1997 - 1998, 2000 Corvette: Service Bulletin: Electronic Steering Column Lock May Refuse to Operate - DIC Service Message Displayed

Number: 01-02-35-008

Subject: Electronic Steering Column Lock May Refuse to Operate - DIC Service Message Displayed (Update Column Lock Wiring, Install Revised Relay and/or Replace Electronic Column Lock)

Model Year: 1997-1998, 2000 Chevrolet Corvette Built Between the Following VIN Breakpoints:

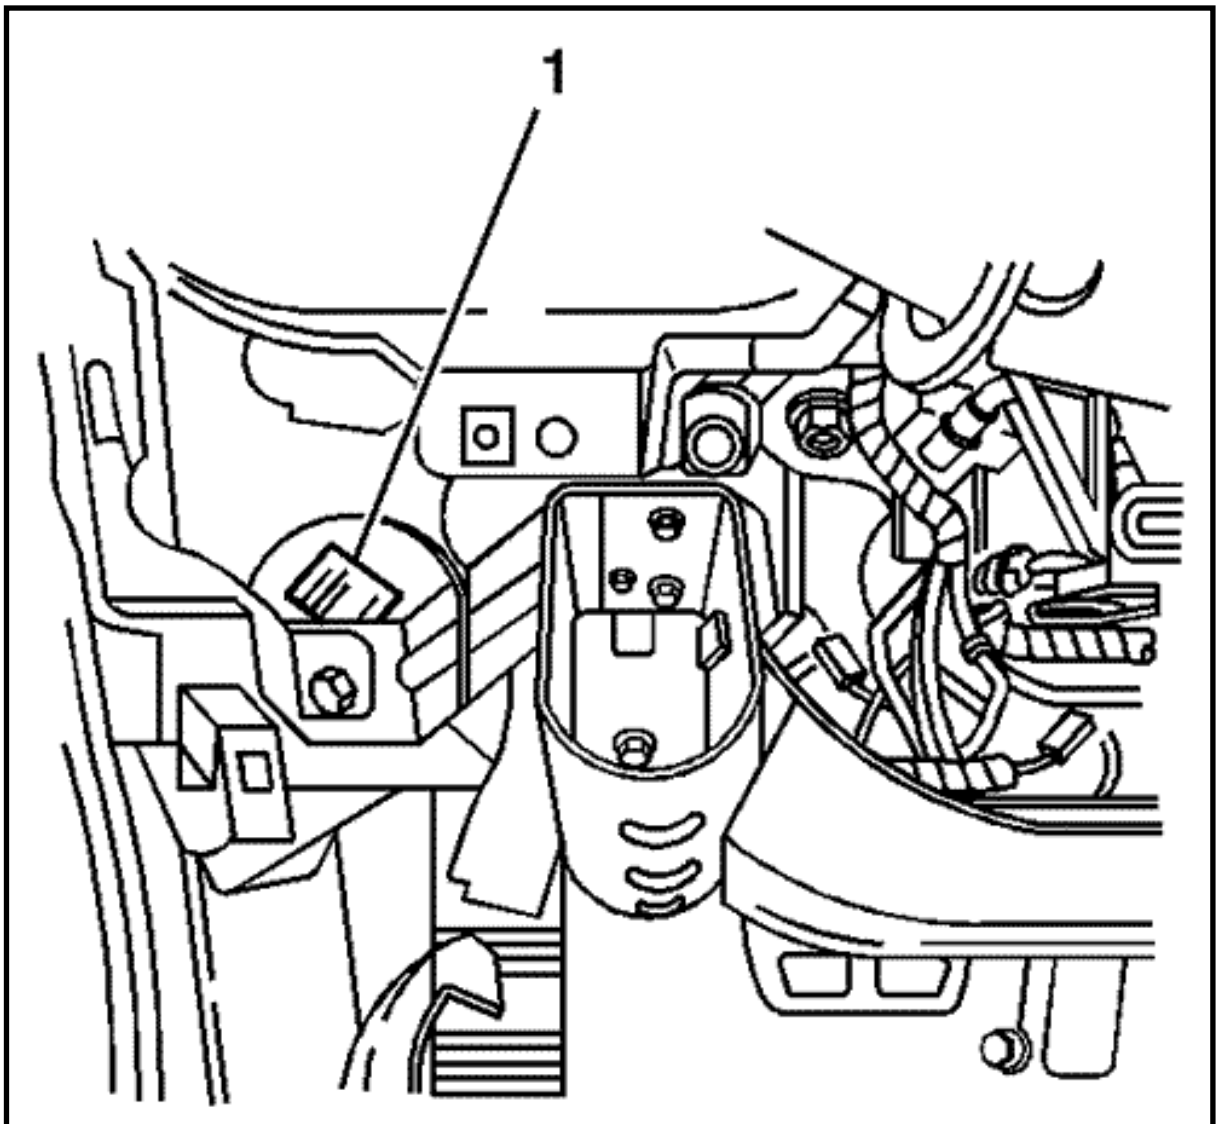
12. Remove and discard the Steering Column Lock/Cam Orientation plate

using the J 38364.

13. Install the included Cam Orientation Plate and secure with a new locking ring, using J 42137 and J 38364 as shown.
14. Install the SIR coil and secure with snap ring.
15. Disconnect the connector from the ECL (located on the right lower side of the steering column) to the I/P main harness.

FIGURE 1997 and 1998 (early) Manual (U.S. & Canada and All Export (Manual & Auto)(c)

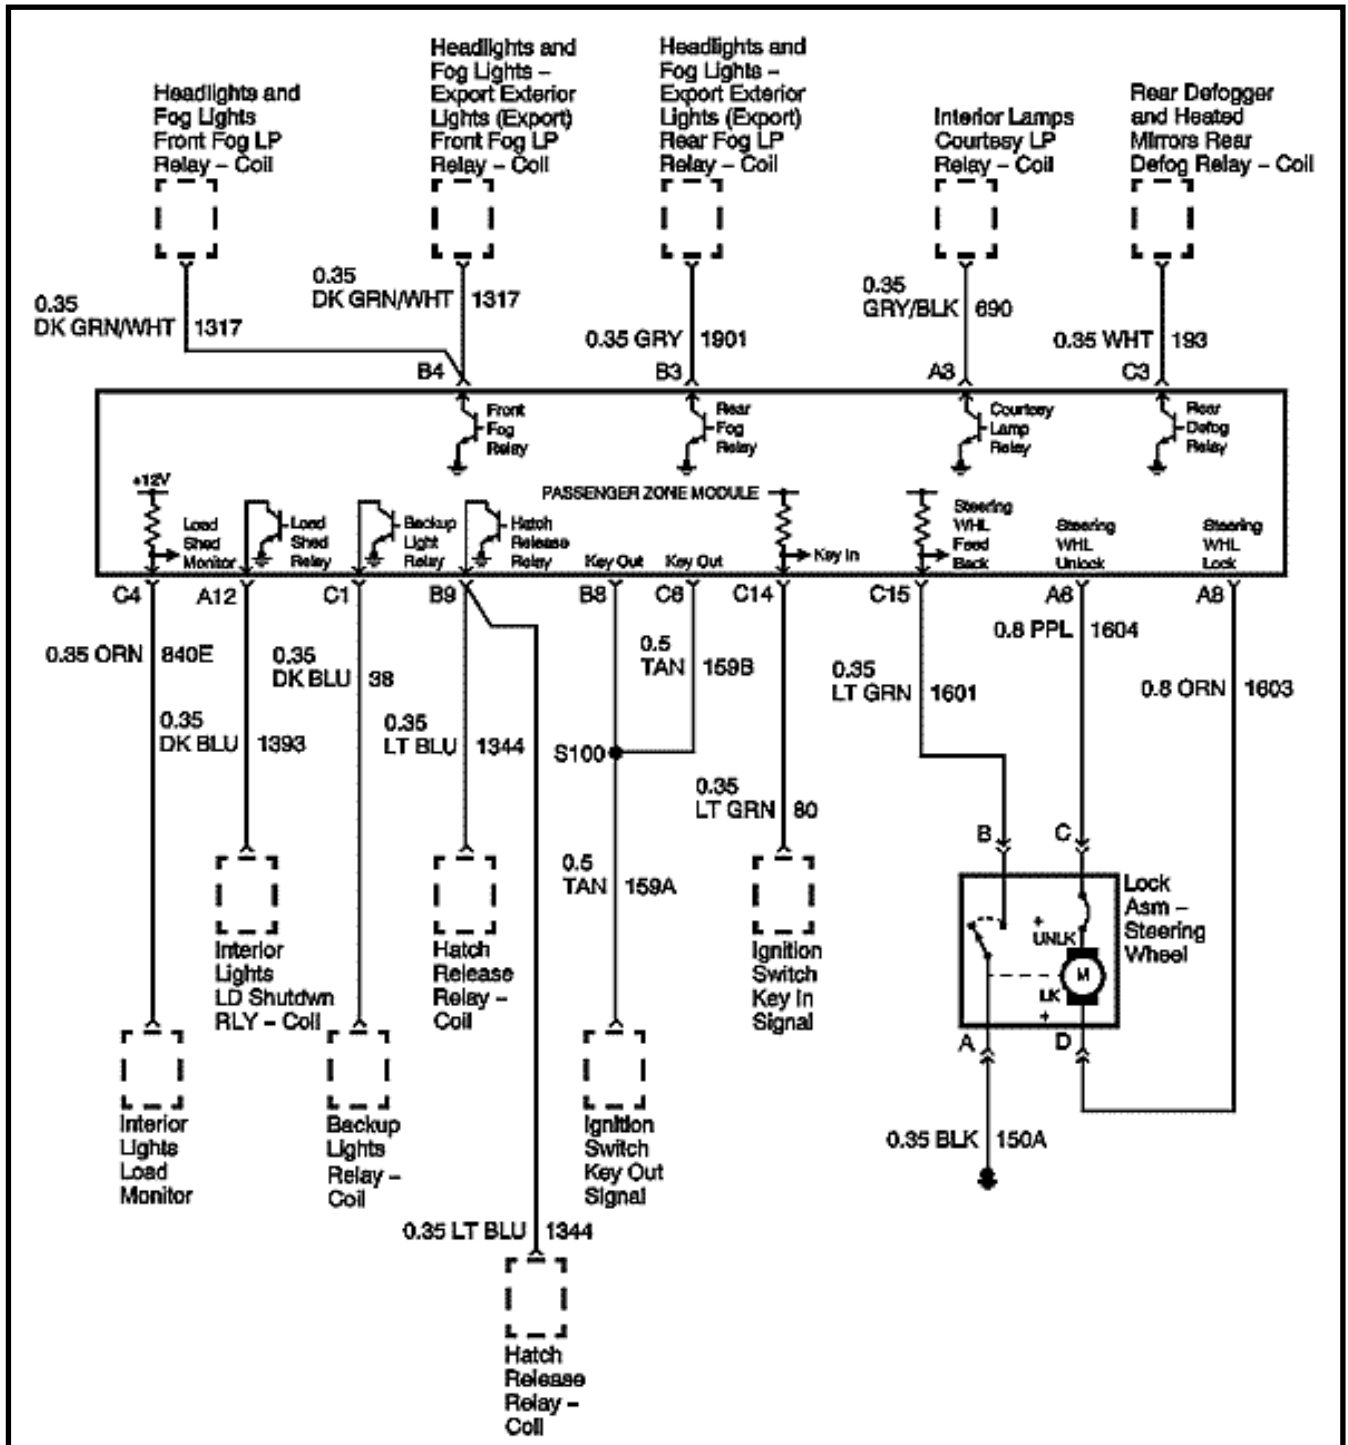
- **In order to complete the wiring upgrades listed in the section, you will need to order P/N 88952428, Wire Kit, Strg Wheel Theft Dtrnt.**
- **You may use the included schematics to aid in verifying the installation of the new relay and jumper wire.**

FIGURE 1997 and 1998 (early) Automatic (U.S. & Canada)(c)

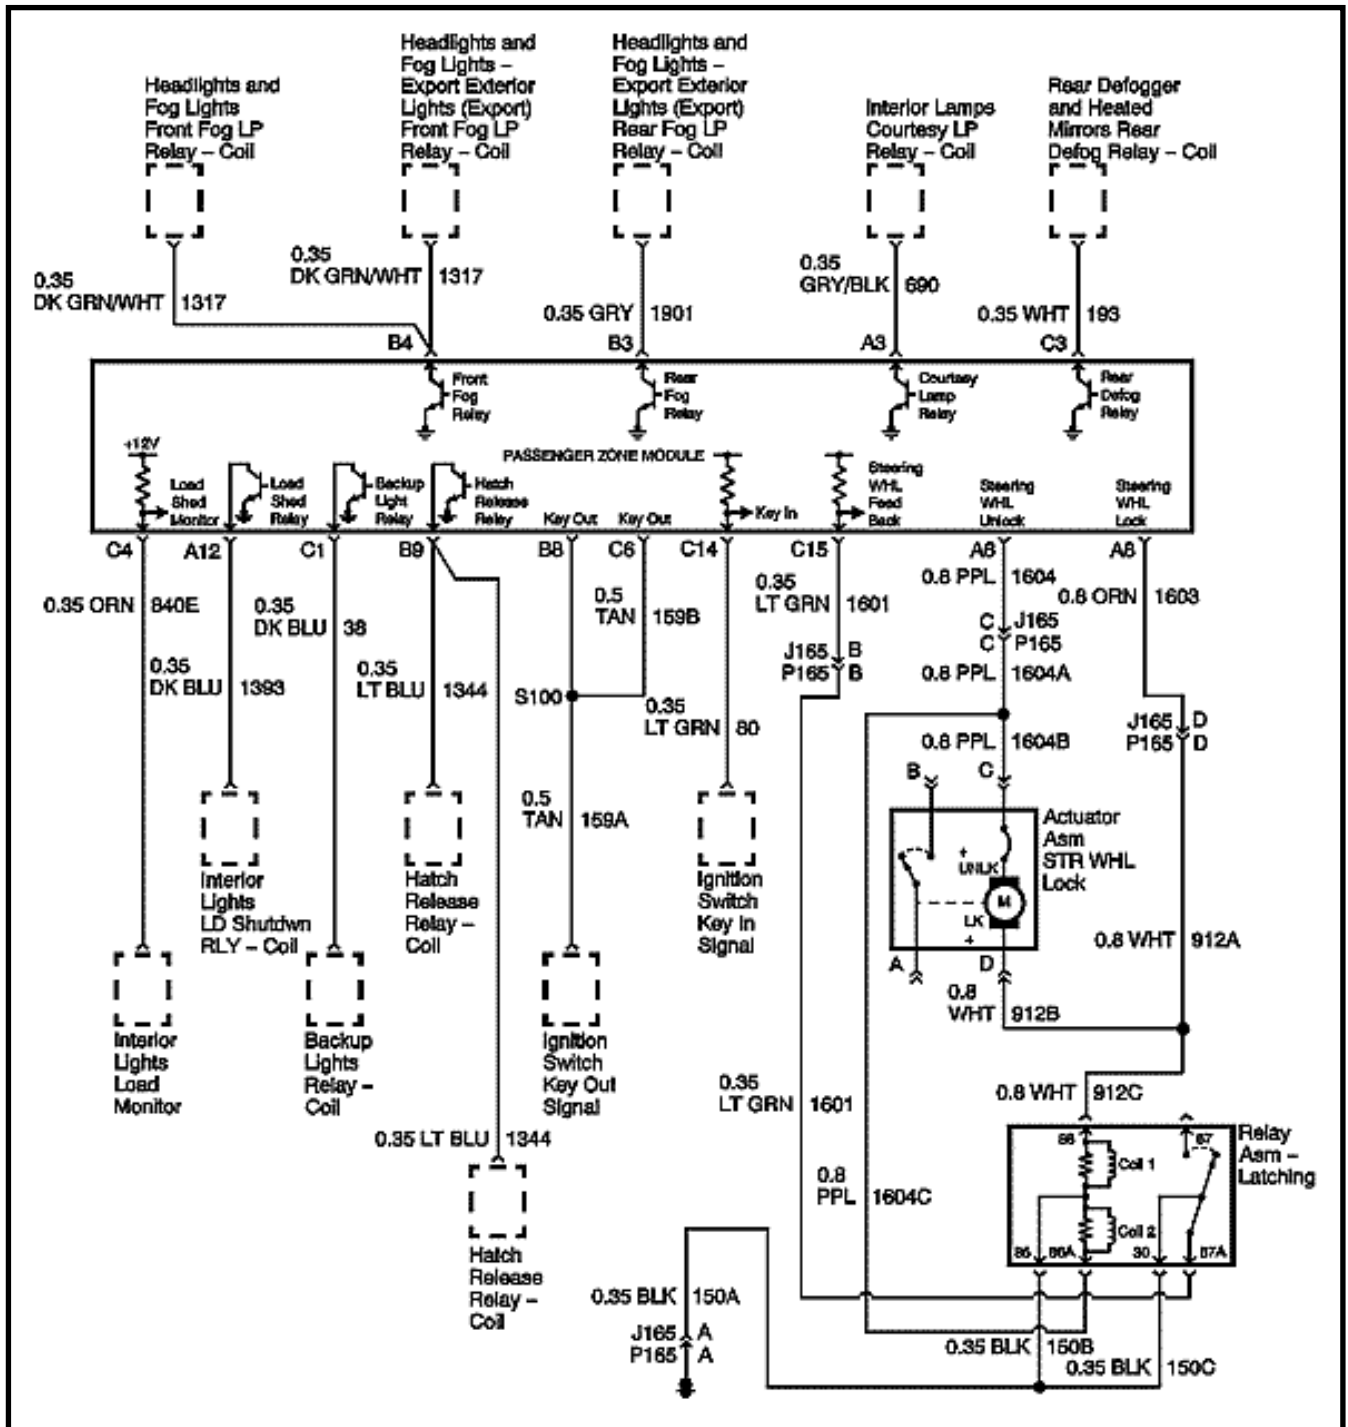
- **When removing the driver's side knee bolster trim panel as described below, care must be taken not to damage the console trim plate as the knee bolster trim panel tucks in behind the console trim plate.**
- **Revised schematics are included to aid and/or verify the proper installation of the service kit.**

FIGURE 2000 (late) Manual and All Export (c)

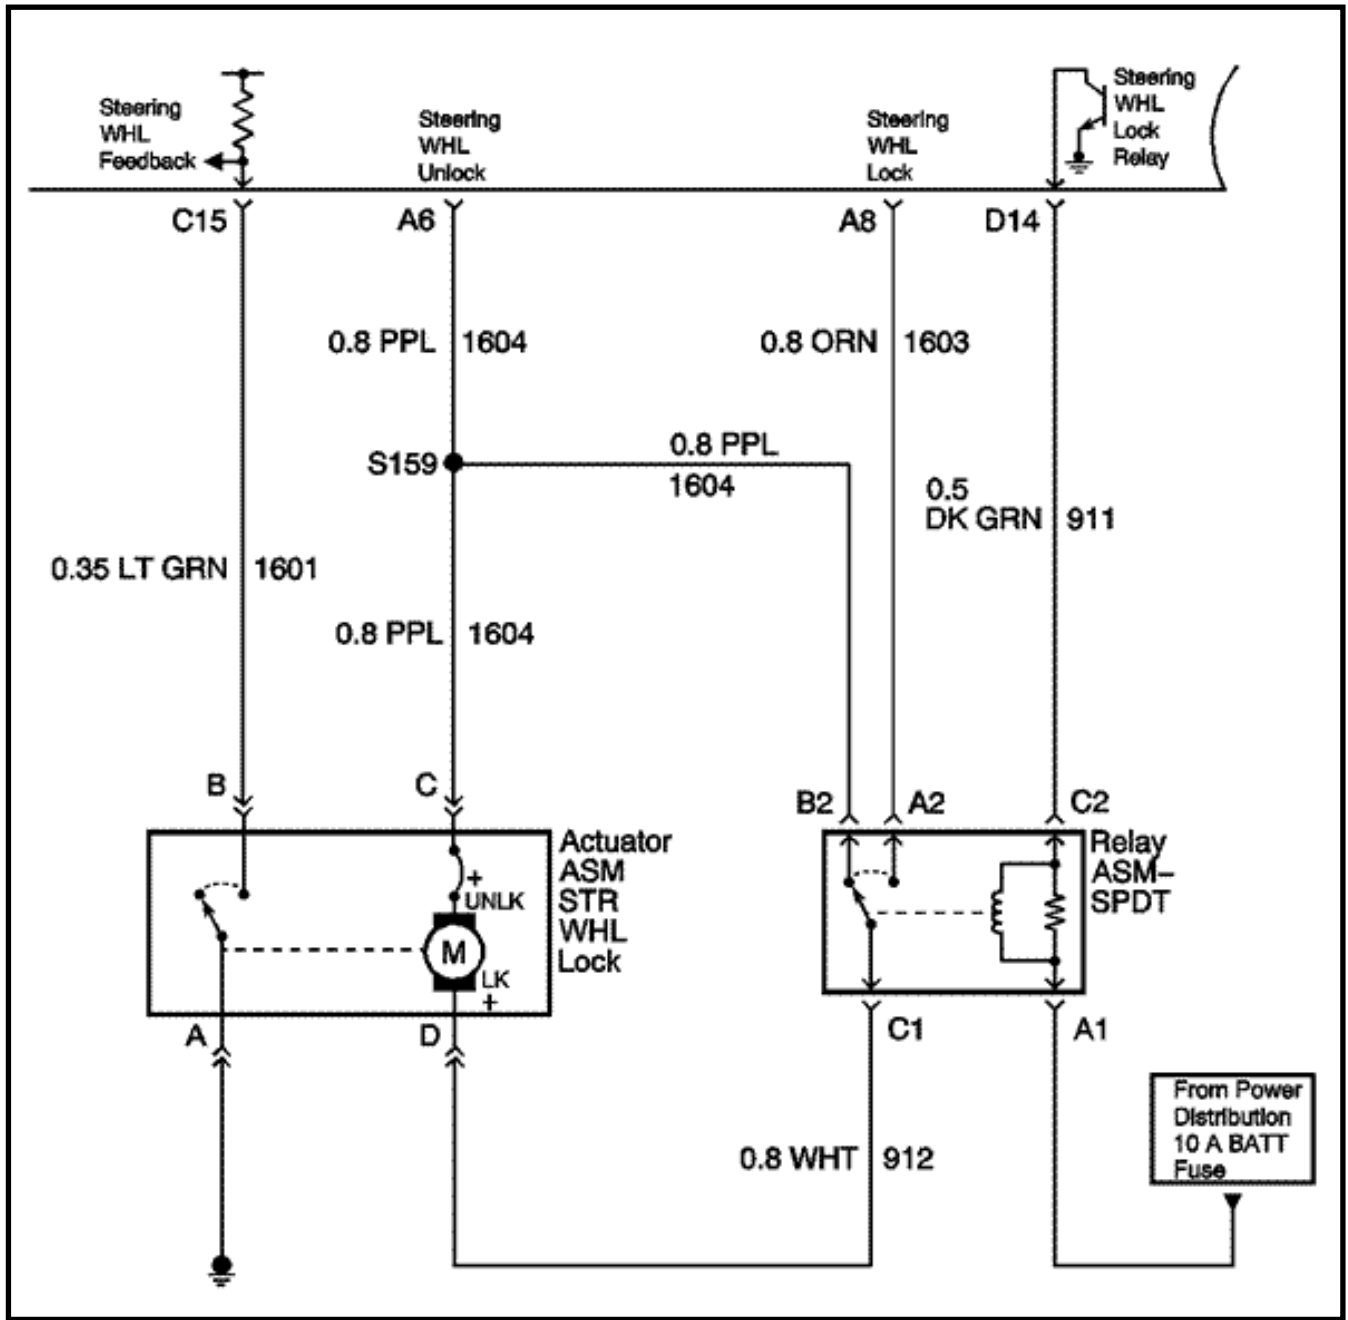
9. Remove the ECL relay harness from the backside of the relay assembly.
10. Remove the relay.
11. Remove the orange wire from position C1 on the ECL relay connector.

12. Remove the white wire from position A2 on the ECL relay connector.
13. Swap the two terminal positions and re-insert, orange wire to A2 and white wire to C1.

14. Add the new purple wire from the jumper to terminal position B2.
15. Install the new single pole, double throw relay.
16. Install the Green 16-way connector to the BCM.
